# 2006 - 2009 Cadillac XLR XLR-V: Service Bulletin: Slips in Reverse or Third, Delayed Reverse or Drive Engagement

## #09-07-30-004J: Slips in Reverse or Third, Delayed Reverse or Drive Engagement, DTC P0776, P2715, P2723, Harsh 2-3 Shifts (Inspect 1-2-3-4 / 3-5-R Housing and Pump Seal Rings) - (Feb 25, 2014)

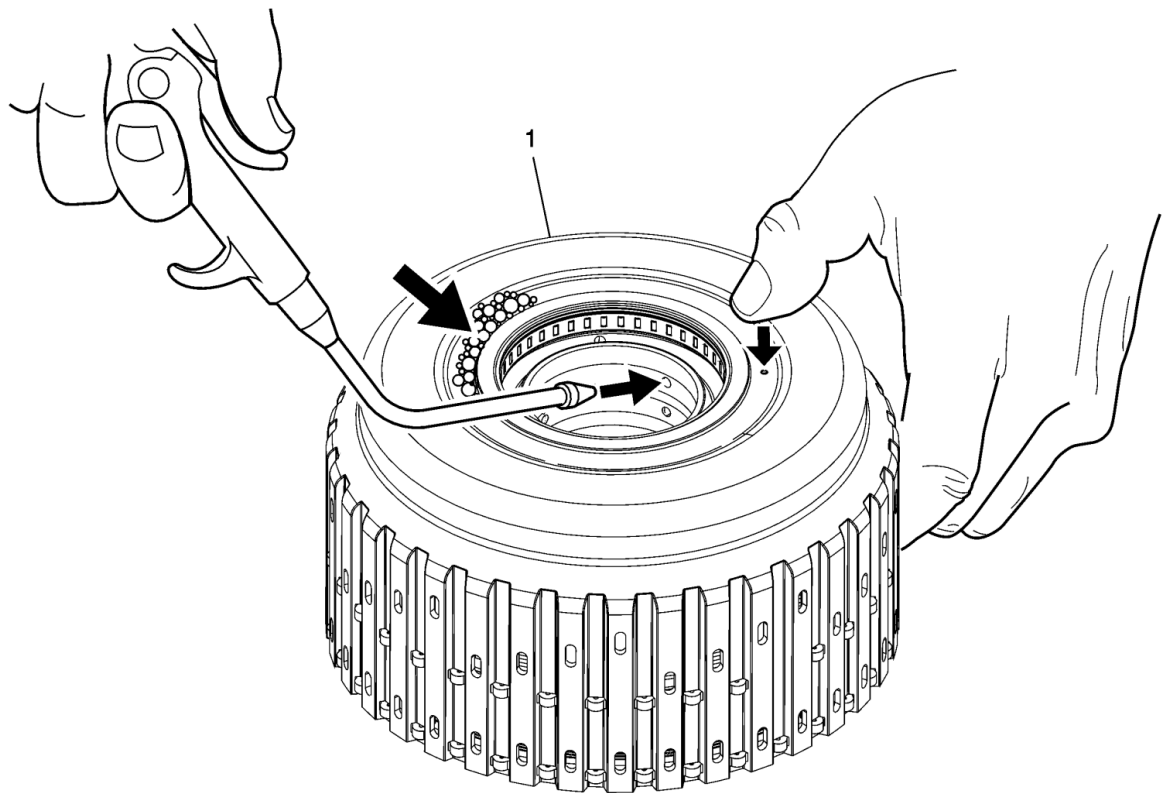
This condition may be caused by a cracked 1-2-3-4 / 3-5-R clutch housing.

**Important:** If a cracked housing is identified, it must be replaced. Complete, assembled 1-2-3-4 / 3-5-R clutch housings are now available for most applications. These clutch housings come complete with all pistons, seals, clutches, bearing and internal parts. No assembly of the clutch housing is required before it is installed. For applications without a complete, assembled 1-2-3-4 / 3-5-R clutch housing, individual parts must be ordered and the housing assembled in the dealership.

### **Housing Disassembled**

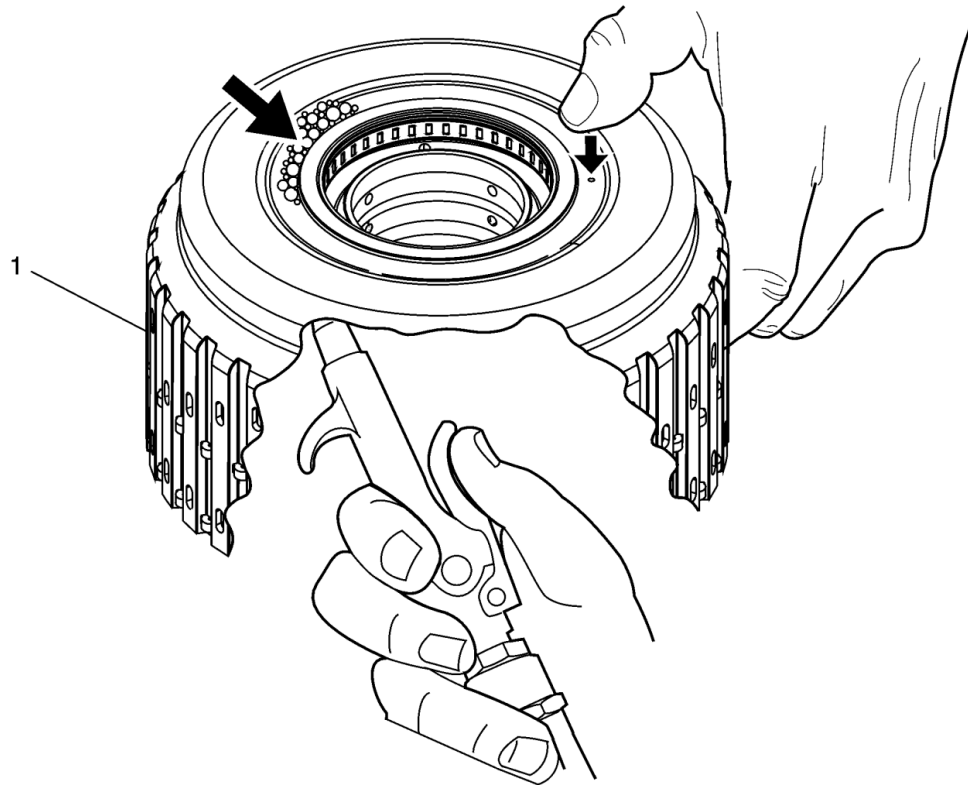
Inspect the 1-2-3-4 / 3-5-R clutch housing for a possible cracked weld.

1. Apply soap compound to weld area of the housing.
2. Hold your thumb over the air bleed passage.
3. Spray compressed air into the housing and inspect the weld area for bubbles.
4. If bubbles are detected, a new housing is required.

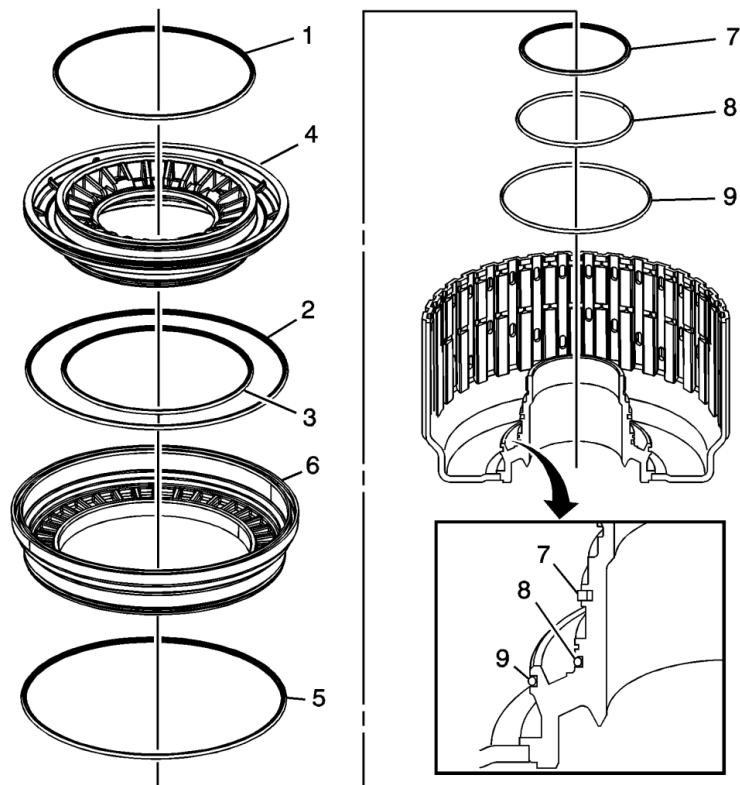
**Important:** The 6L80 transmission had a design change to the 1-2-3-4 piston, 1-2-3-4 piston housing and the 3-5-R piston for the 2008 model year. Installation of a 2008, 6L80 complete housing assembly into a 2007 or older 6L80 may result in a 2-3 shift flare or 3-5-R clutch distress.

**Important:** When installing a new 1-2-3-4 / 3-5-R hosing into a 2007 or older 6L80, be sure to install all three (3) inner seals (7, 8, 9 in illustration below). Failure to install these seals can result in no reverse, no forward or distressed clutches.

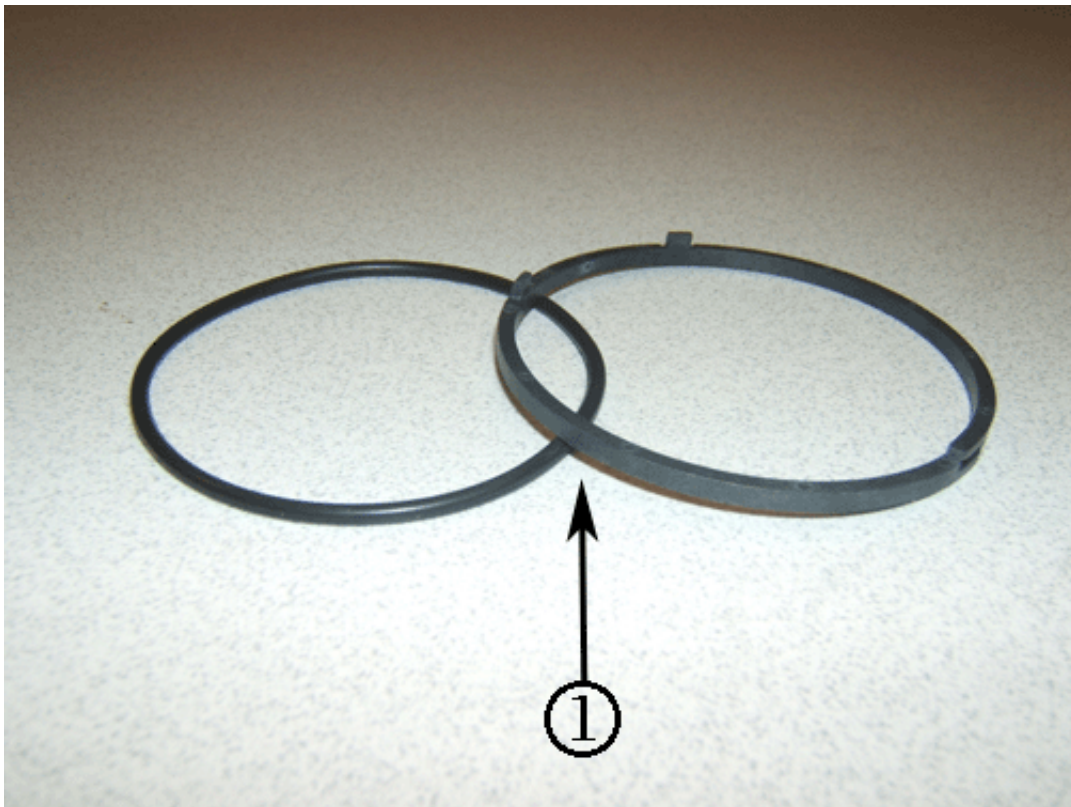
A harsh 2-3 shift condition may be caused by leaking 1-2-3-4 and 3-5-R clutch fluid seal rings (1) on the transmission fluid pump cover assembly.

Inspect the fluid seal rings. Transmissions in 2006, 2007, 2008 and early build 2009 models used a 1- piece design seal ring in production. Starting December 2008, a 2-piece seal ring design was implemented. The 1-piece seal ring design may cause a harsh 2-3 shift

due to leakage. This is typically a low mileage issue. If the seal rings are a 1-piece design they should be replaced with new 1-piece design seal rings. It is not necessary to replace the pump cover.

**Notice:** The clutch fluid seal rings must be installed in a specific way. Failure to install new clutch fluid seal rings in the proper orientation may cause a repeat harsh 2-3 shift. Refer to 1-2-3-4 and 3-5 Reverse Clutch Fluid Seal Ring Installation (6L80/90) in SI for correct installation.
